Access Compliance Report

Public Rights-of-Way

(Curb Ramps)

Intersection ID: 49151	Main Street: DACAVIN_DR	Cross Street: VIDAL_LN	Location: NW
ADA ID: C11ADDEDC186	Ramp Type: ParaDiag	Initial Pass/Fail: Fail	Overall Compliance: No
			Severity Score: 33.75

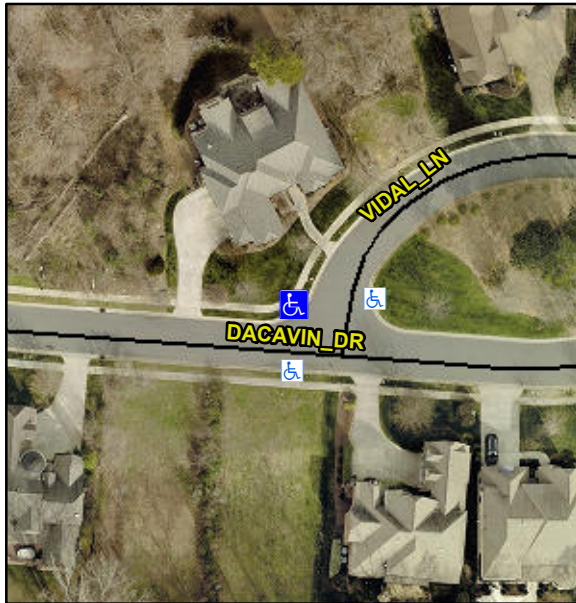
R304.5.1, R304.3.2

Compliance	Description	Data	Compliance	Description	Data
N/A	Ramp Length LT (in)	42.0	N/A	Ramp Length RT (in)	37.0
No	Ramp Width LT (in)	46.5	Yes	Ramp Width RT (in)	48.0
No	Ramp Slope LT (%)	12.7	Yes	Ramp Slope RT (%)	7.0
Yes	Ramp XSlope LT (%)	1.2	Yes	Ramp XSlope RT (%)	0.8
N/A	Landing Length (in)	N/A	N/A	DWS Provided?	N/A
N/A	Landing Width (in)	N/A	N/A	DWS Contrast?	N/A
N/A	Landing Slope (%)	N/A	N/A	DWS Length (in)	N/A
N/A	Landing X Slope (%)	N/A	N/A	DWS Full Width?	N/A
N/A	Landing Curb? (Y/N)	N/A	N/A	DWS Offset (in)	N/A
N/A	Shared Landing?	N/A			
N/A	Gutter Ponding?	N/A	N/A	Gutter Slope (%)	N/A
N/A	Gutter Lip Ht (in)	N/A	N/A	Gutter X Slope (%)	N/A
N/A	Painted X Walk1?	No	N/A	Painted X Walk2?	No
	X Walk 1 Direction	To S		X Walk 2 Direction	To E
N/A	X Walk 1 Width (in)	N/A	N/A	X Walk 2 Width (in)	N/A
	X Walk 1 Slope (%)	0.2		X Walk 2 Slope (%)	5.6
	X Walk 1 X Slope (%)	11.1		X Walk 2 X Slope (%)	0.3
N/A	Ramp inside XWalk1?	N/A	N/A	Ramp inside XWalk2?	N/A

Road Slope (%)	5.5	N/A	Clear Space?	N/A
	Road X Slope (%)	7.0	N/A	Clear Space to XWalk (in)	N/A
N/A	Any Obstructions?	N/A	N/A	Storm Grate/Utility Hazard?	N/A
	Obstruction Type			Storm Grate/Utility Type	
		N/A			N/A
			Yes	Surface Condition? (G/P)	Good
			N/A	Curb Slope (%)	9.5

Remove & Replace Curb Ramp With Two New Directional Ramps or Equivalent.
